**UNITED STATES
NUCLEAR REGULATORY COMMISSION**
WASHINGTON, D.C. 20555-0001

**SUBJECT: FINAL SAFETY EVALUATION FOR KAIROS POWER LLC TOPICAL REPORT
"KP-FHR RISK-INFORMED PERFORMANCE-BASED LICENSING BASIS
DEVELOPMENT METHODOLOGY" (REVISION 1) (EPID NO. L-2019-TOP-
0009/CAC NO. 000431)**

KP-FHR Risk-Informed Performance-Based Licensing Basis Development Methodology Topical Report			
Non-Proprietary	Doc Number	Rev	Effective Date
	KP-TR-009-NP-A	1	April 2020

Figure 3-2. Process for Selecting and Evaluating Licensing Basis Events

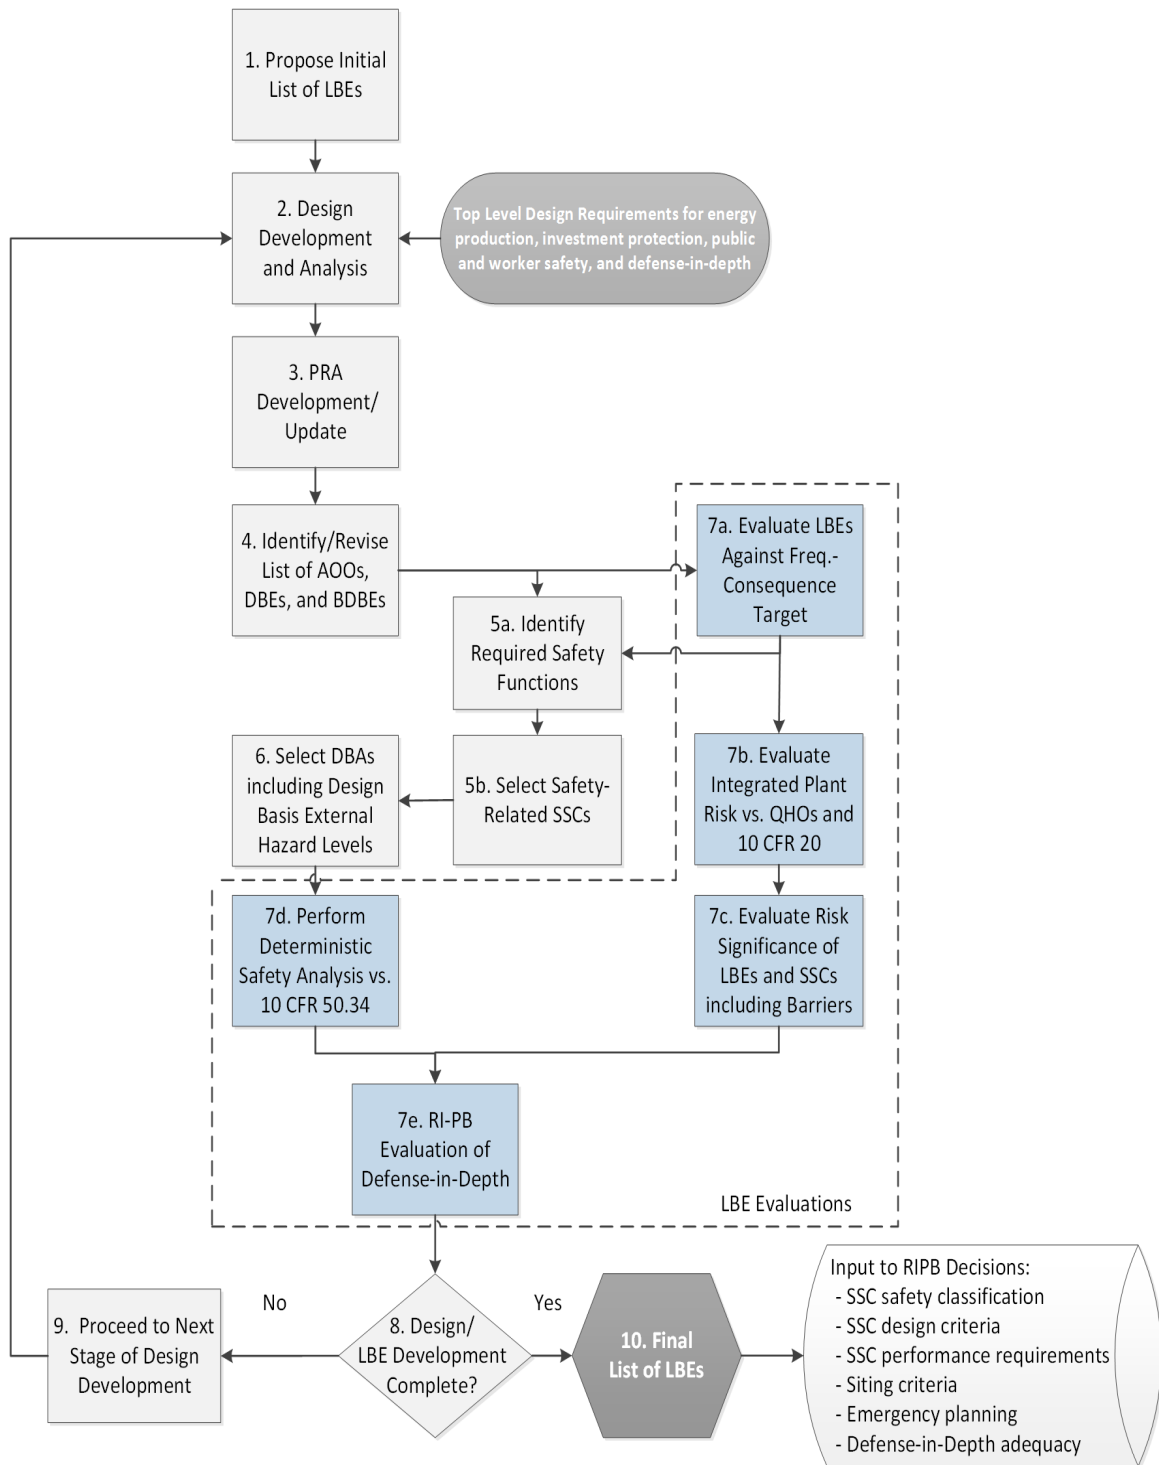
In describing Task 7a (Evaluate LBEs Against F-C Target) of Figure 3.2, this TR replaces the following text in NEI 18-04
